AGENDA ITEM #12

Application for: Preliminary Plat

Location: Ridgway USA Subdivision, Lots 30-34

STAFF REPORT

VP LINE 2,3,& 4 PLAN SCALE: 1"=20'-0"

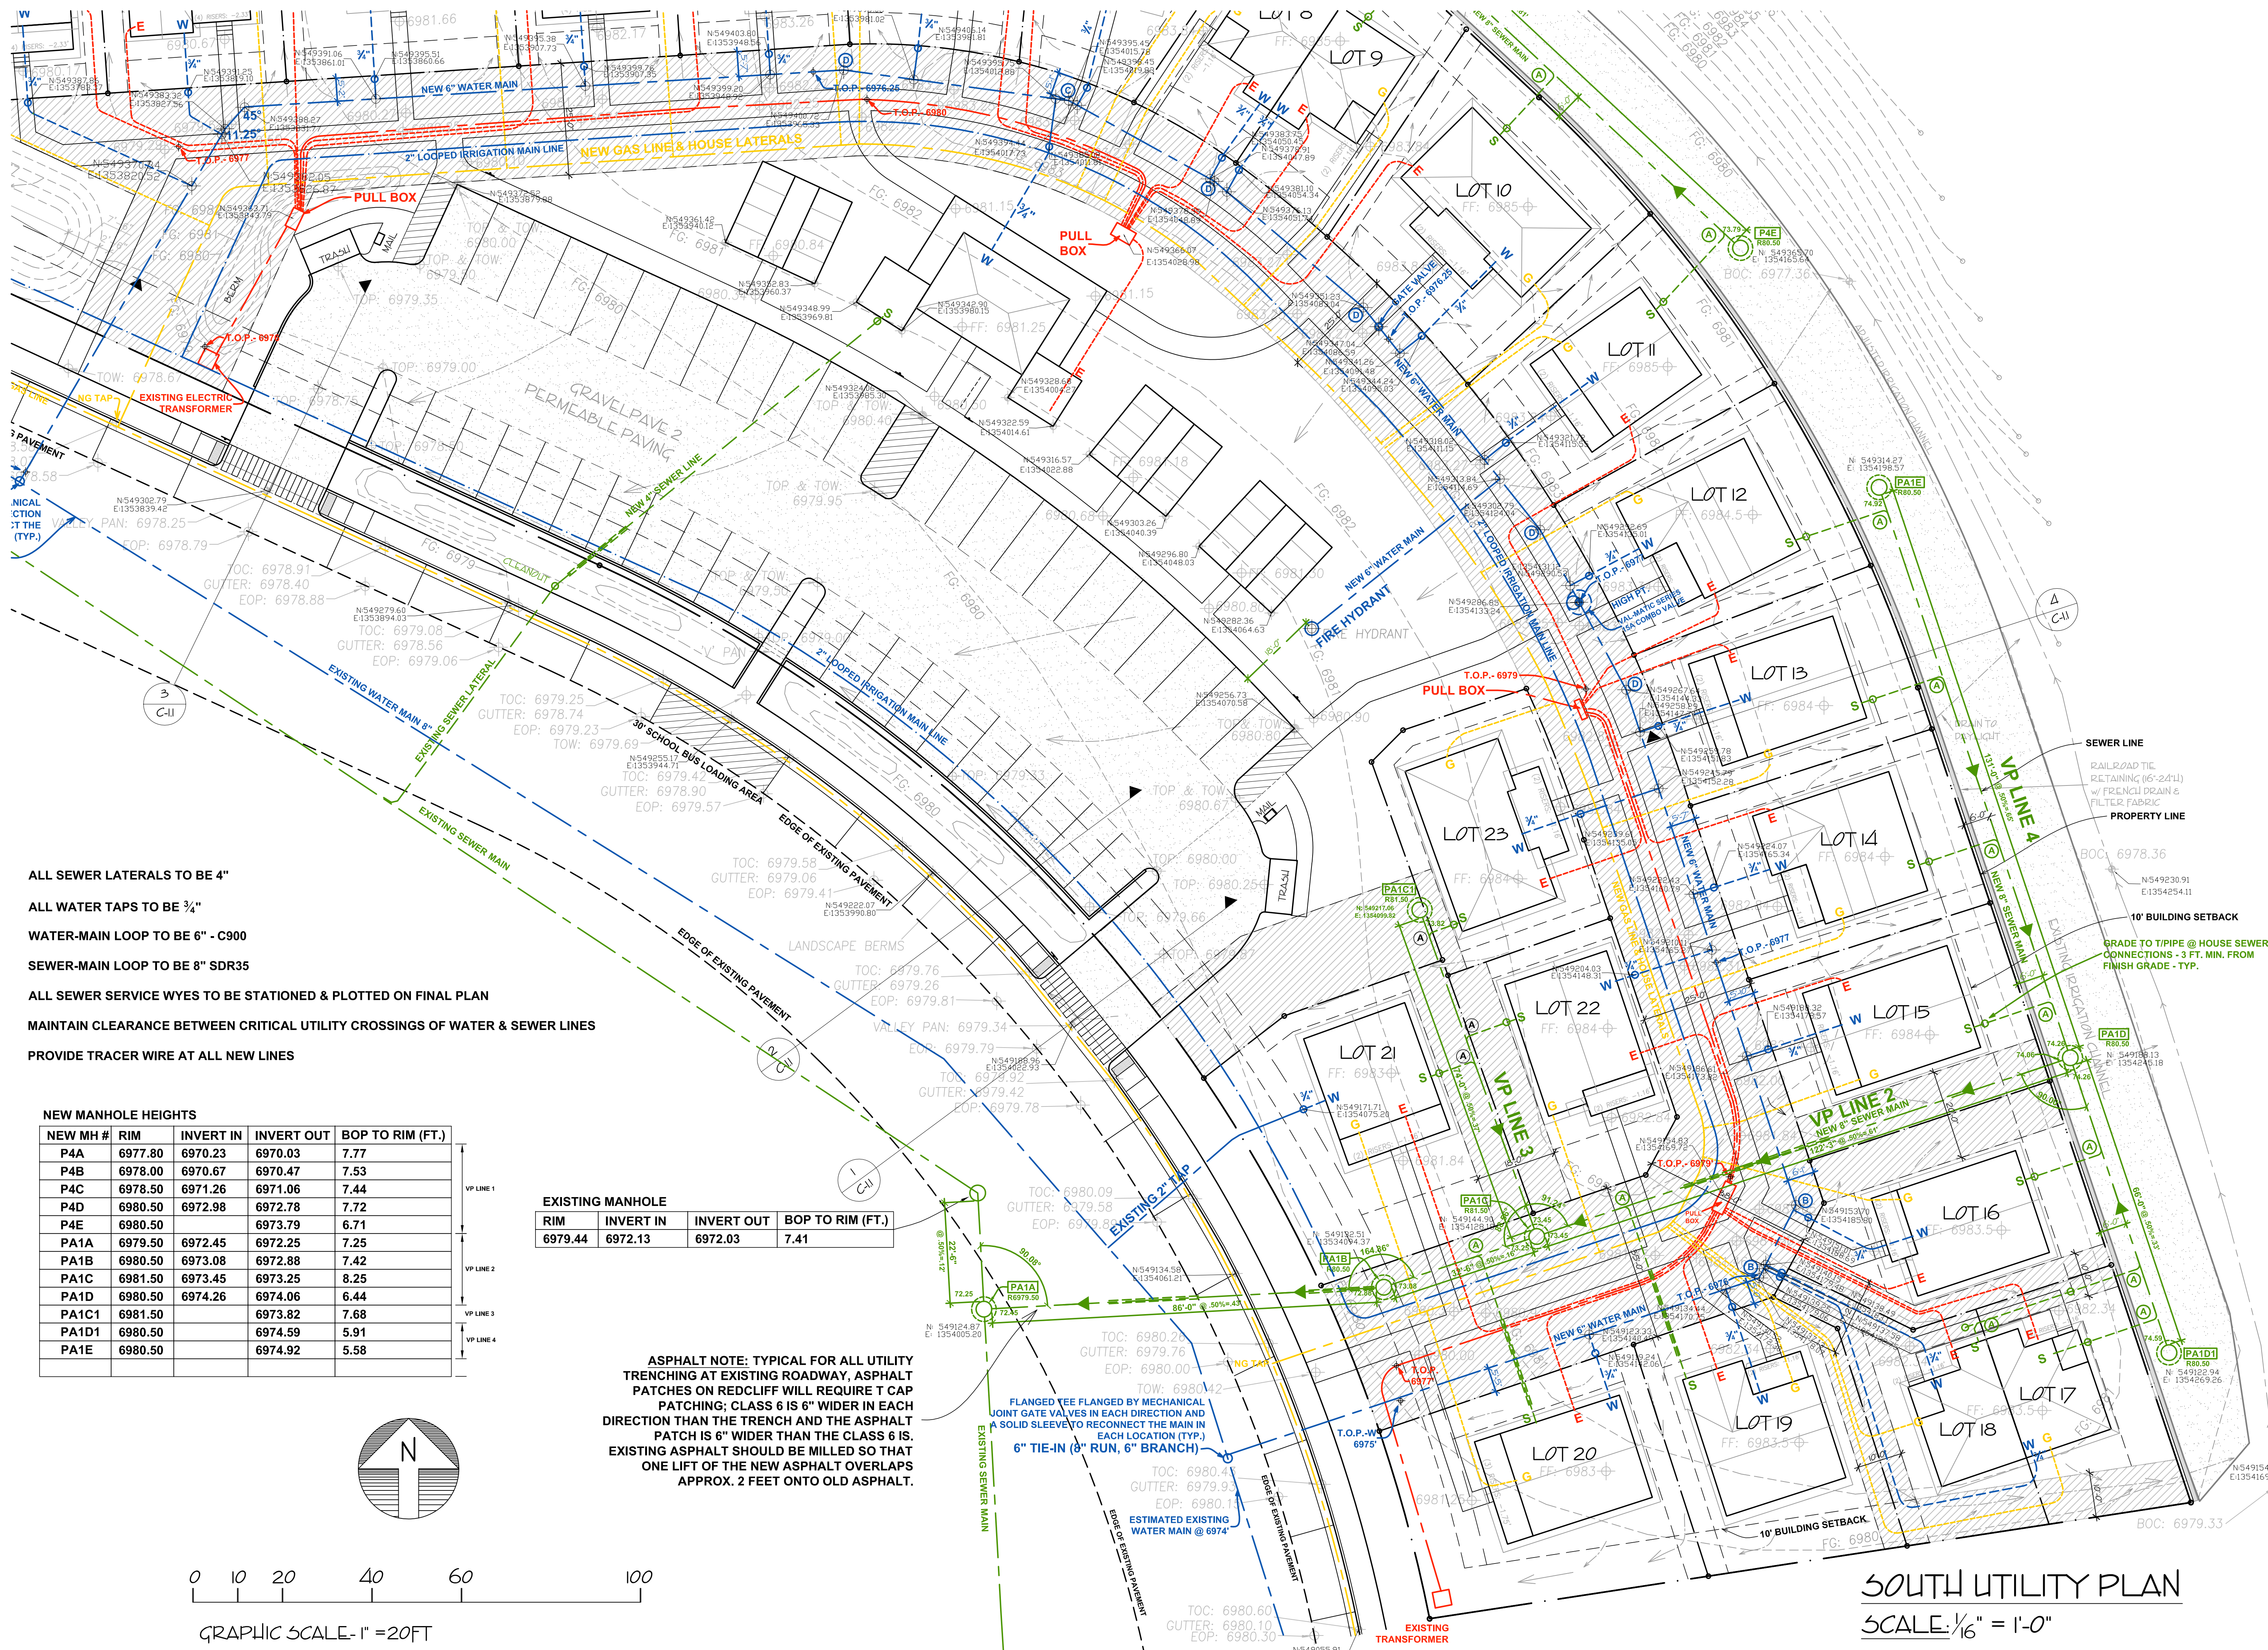
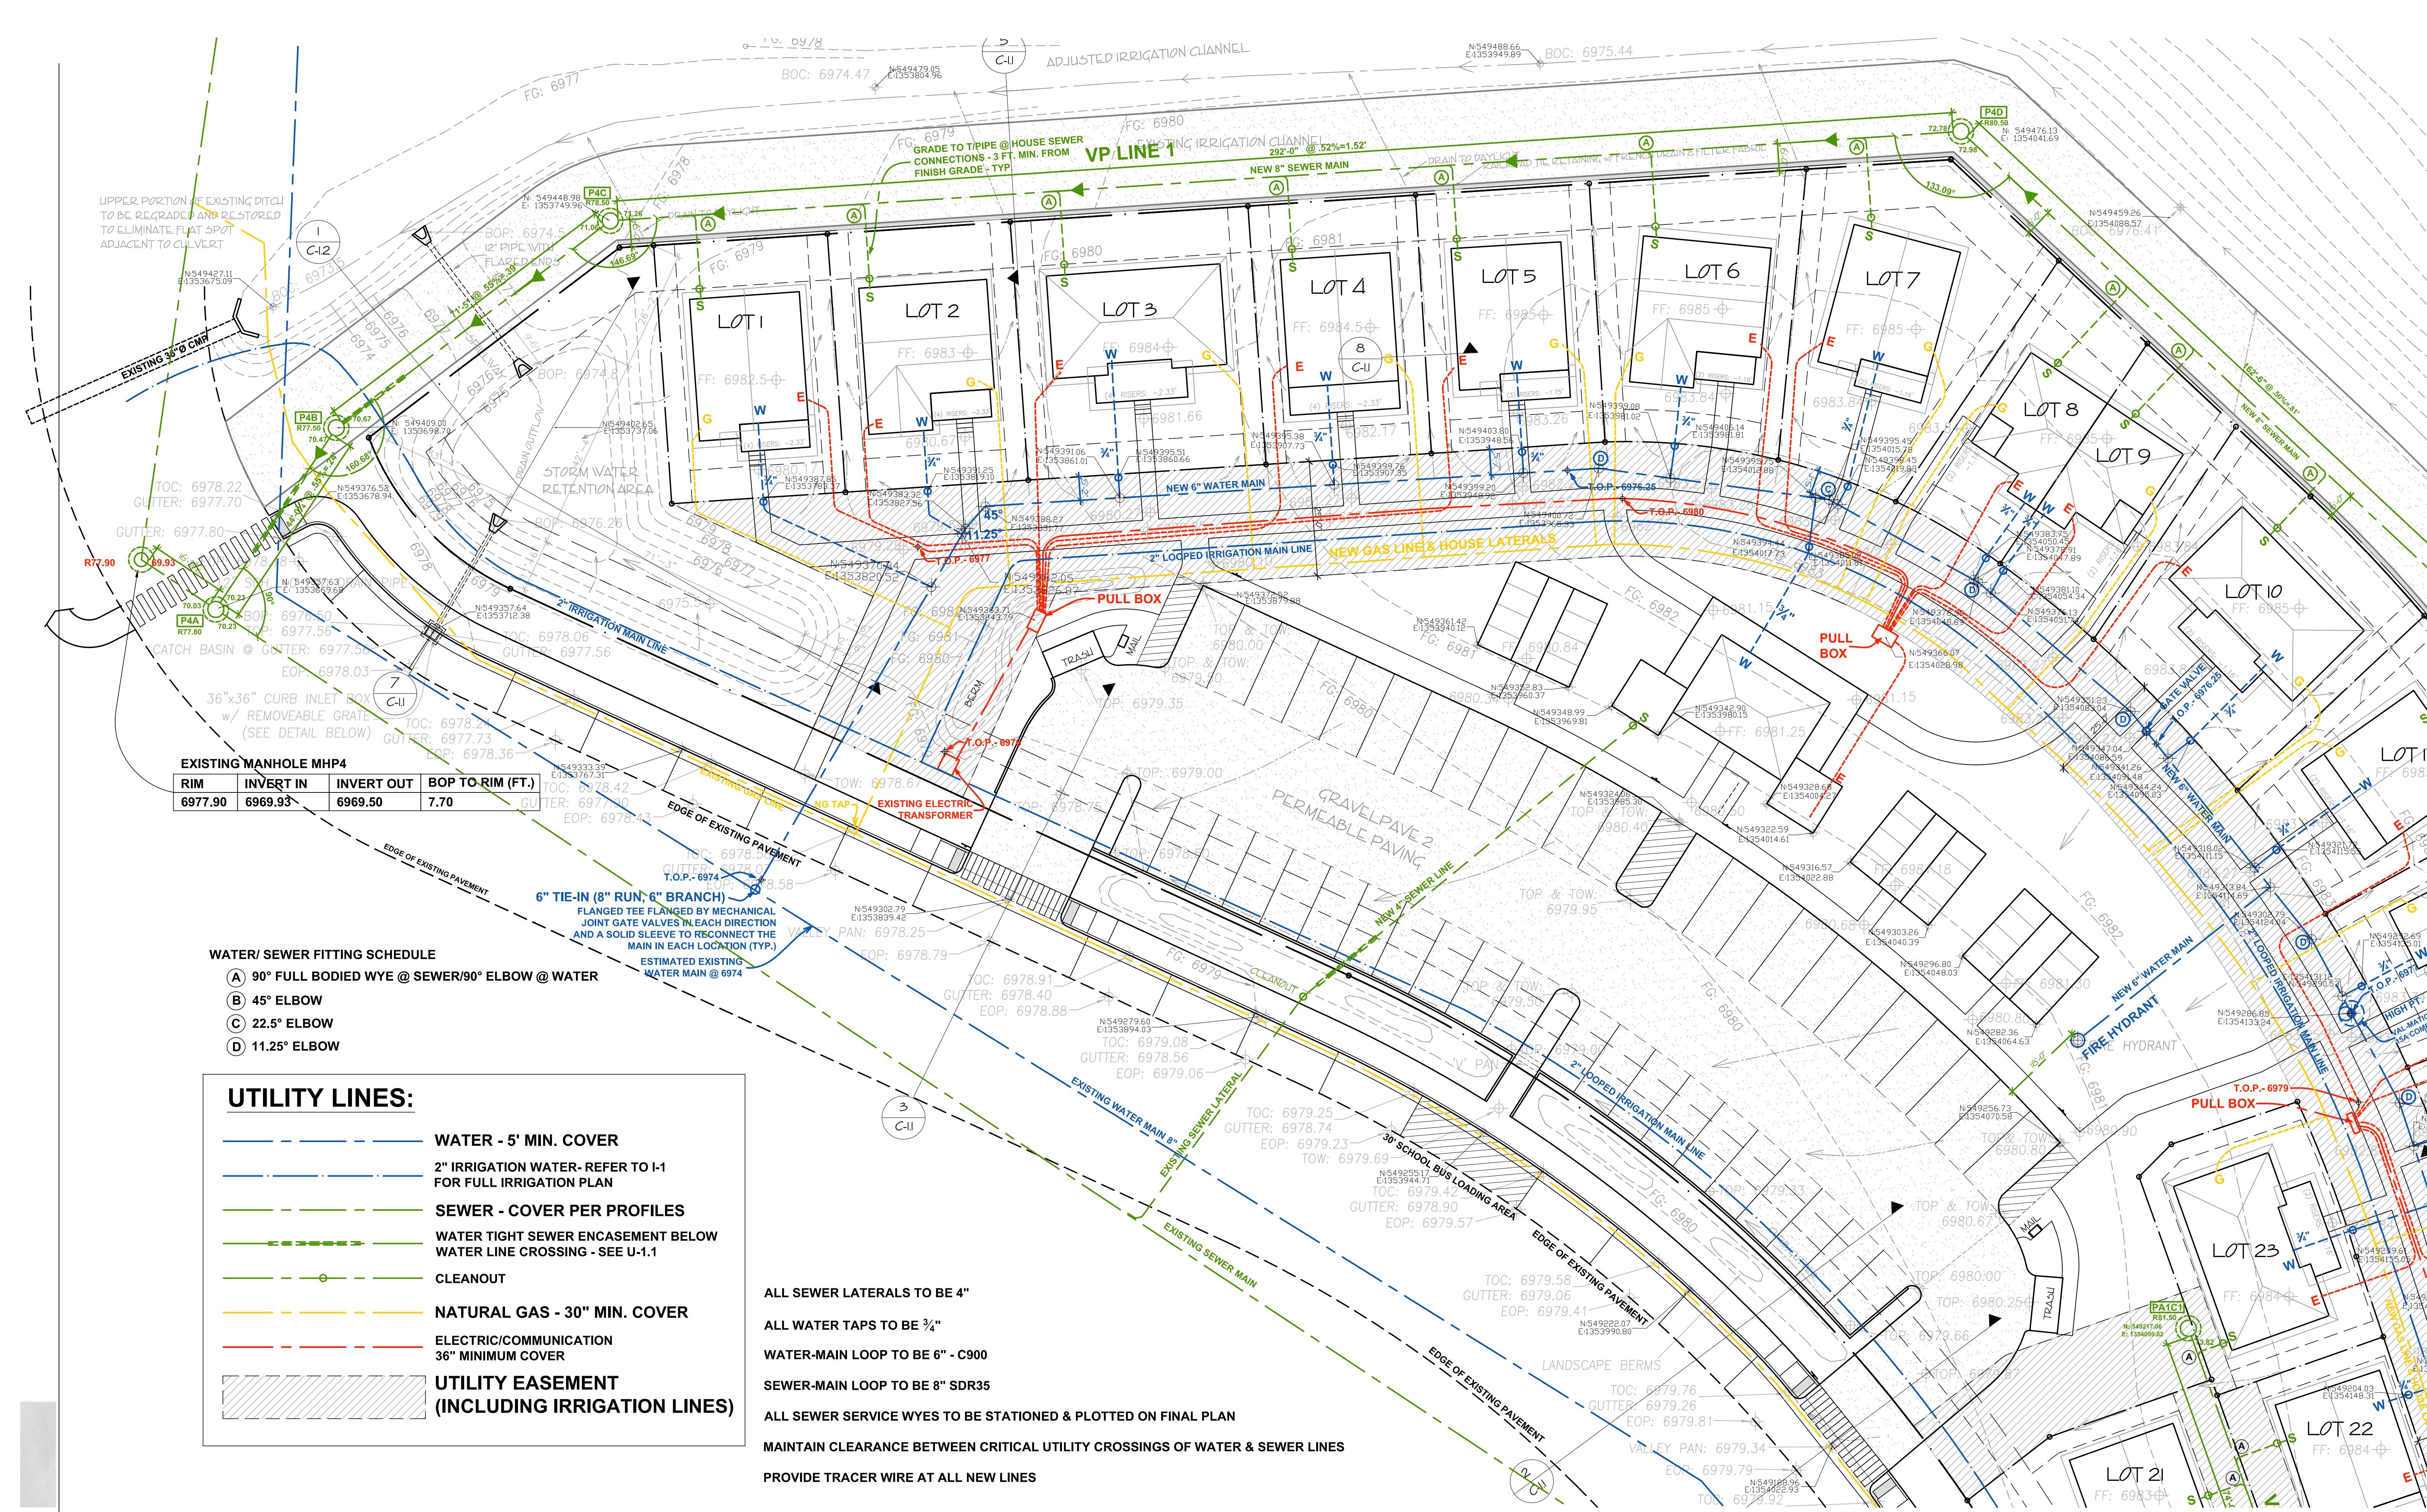
- There are still some discrepancies between the manhole coordinates, the distance between manholes, and the slopes between manholes. On the P4 line, it looks like the distance and slope are reversed between P4A and P4B. When this is corrected the slope will be less than 0.5% so the slope should be increased to 0.5%. Between P4B and P4C, it looks like the designer copied the previous texted and did not change the content. It should be 61.51' and the slope will change to adjust for the previous item. Between P4C and P4D there looks to be an error in the math between the coordinates and the line distance. We calculate 289.49' @0.525% slope. When the slope in the first leg is corrected the rest of the invert elevations and/or slopes will need to be adjusted. On the PA1 between PA1B and PA1C we calculate a slope of 0.523% and between PA1C and PA1D the coordinate distance comes out 121.25 not 122.25'.
